Tender #PW-2025-03 –
Sheridan Rapids Bridges
Replacement
ADDENDUM NO. 4

ADDENDUM NO. 04

QUESTIONS AND ANSWERS

SHERIDAN RAPIDS BRIDGE
STRUCTURAL REHABILITATION
GENERAL ARRANGEMENT
NORTH BRIDGE

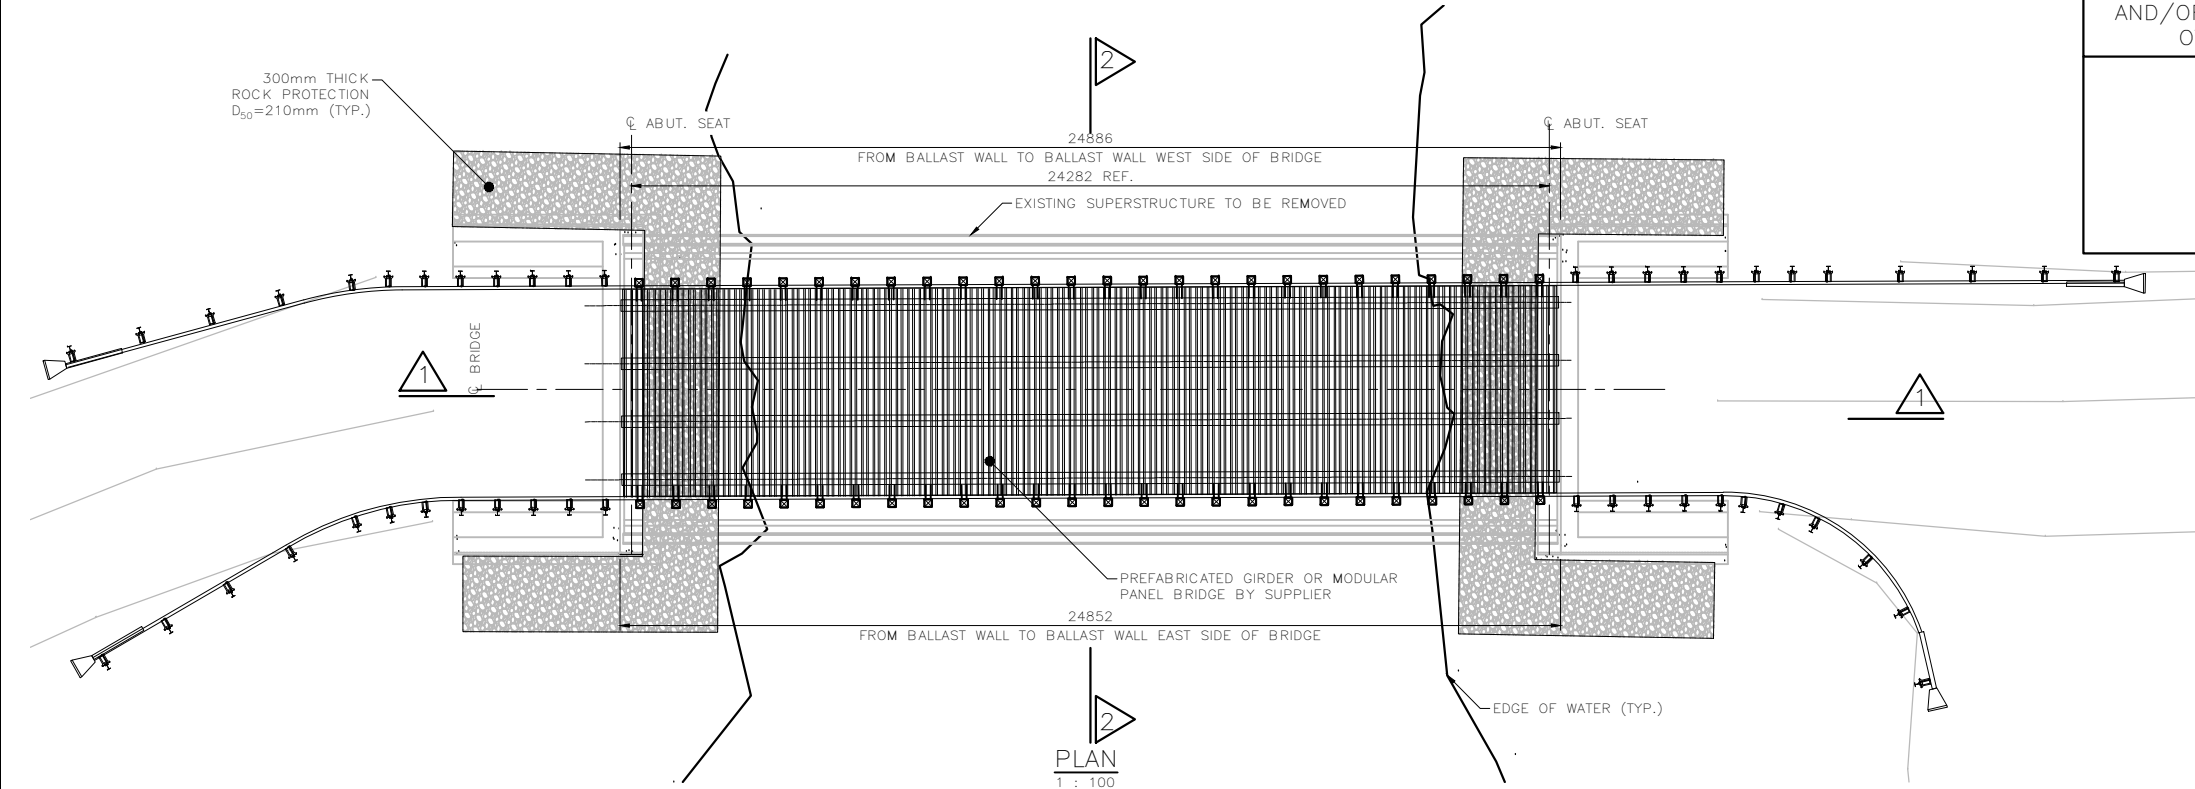
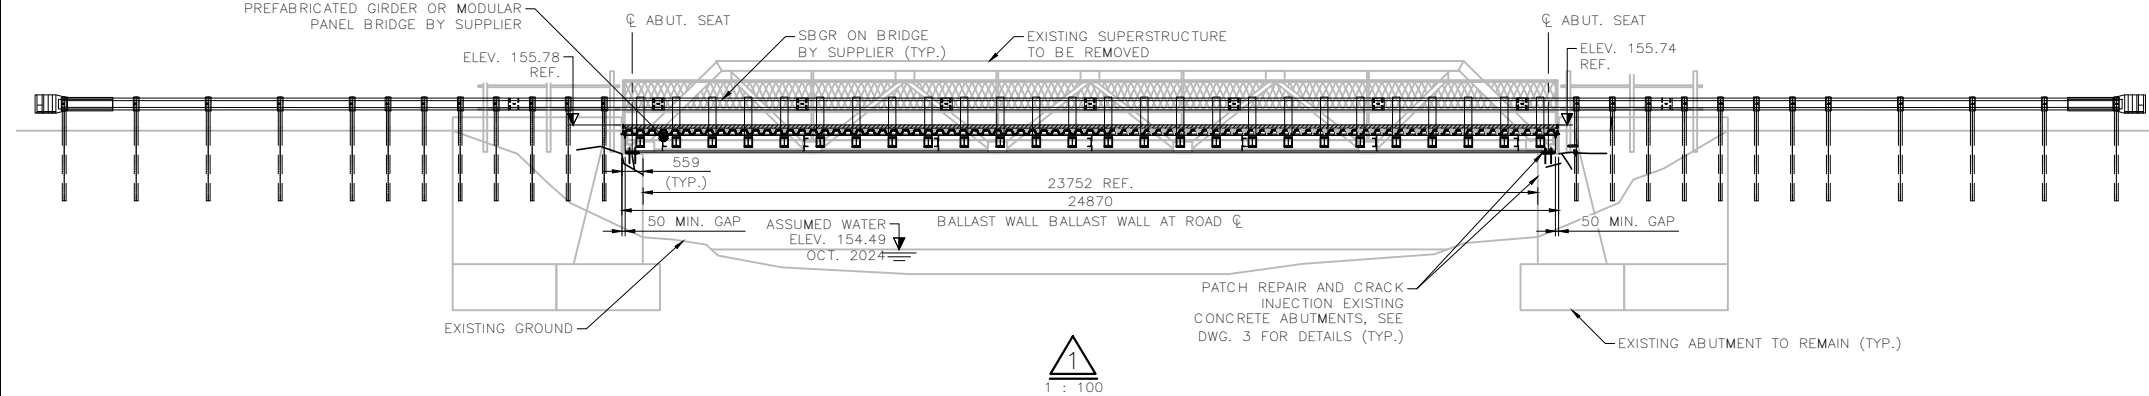
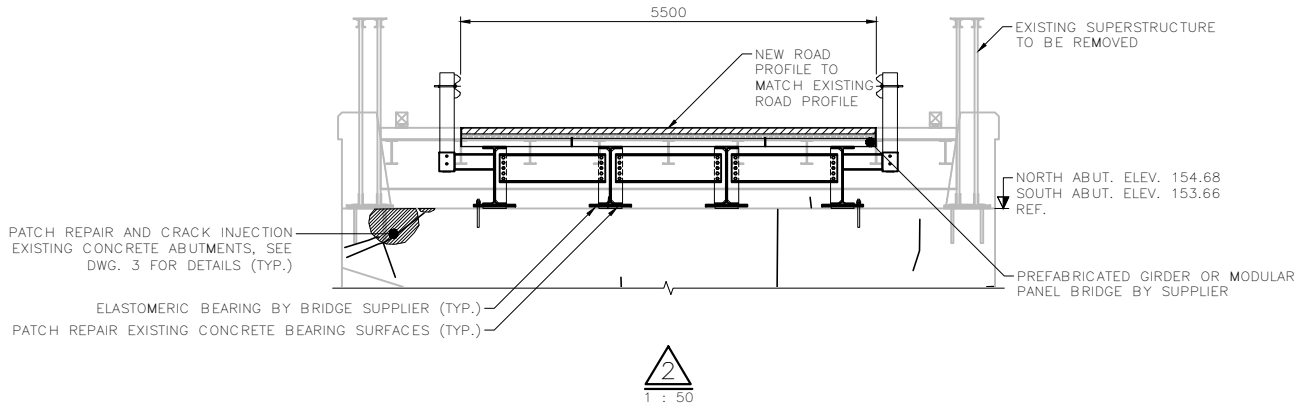
Please note the change in the General Notes in the General Arrangement Drawings.

- PREFABRICATED GIRDER BRIDGE IS SHOWN INDICATIVELY; A MODULAR PANEL BRIDGE IS ALSO PERMISSIBLE. BRIDGE SUPPLIER SHALL DESIGN AND DELIVER REPLACEMENT BRIDGE, BEARINGS, STEEL BEAM GUIDE RAILS ALONG BRIDGE, AND ALL ASSOCIATED COMPONENTS.

- STRUCTURAL STEEL SHALL BE GRADE 350 A (OR APPROVED EQUIVALENT) OR 350 AT (OR APPROVED EQUIVALENT) IF A PREFABRICATED GIRDER BRIDGE IS SELECTED.
- A CORRUGATED STEEL DECK WITH ASPHALT AND GRAVEL TOPPING IS SHOWN, BUT THE FOLLOWING DECK TYPES ARE ALSO PERMITTED:

- PRECAST CONCRETE
 - STEEL PLATE WITH EPOXY COATED AGGREGATE
 - STEEL CHECKER PLATE
- BRIDGE DESIGN SHALL BE IN ACCORDANCE WITH THE CANADIAN HIGHWAY BRIDGE DESIGN CODE (CAN/CSA S6-19).
